SS 783-WST Progressive Low Voltage Disconnect Parameter Update

57X vehicles built between July 1st, 2021 and February 5th, 2025.

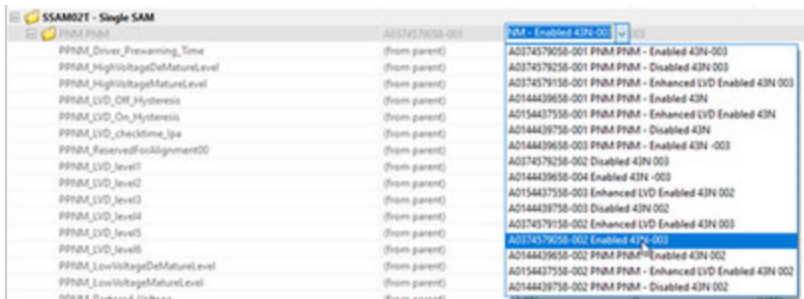
5. Select the part number below in the drop down menu for the PNM group as shown below. **The selection needs to be the next revision of the currently equipped parameter. Please see table below for reference.**

Example: A0374579058-001 Enabled 43N-003 → A0374579058-002 Enabled 43N-003

6. Verify the adjusted parameters are showing the correct values. If matching the values below, click **Send**.

Note: These two parameters are the ONLY adjustments.

PPNM_LVD_checktime_lpa = 10

PPNM_ReservedForAlignment00 = 0
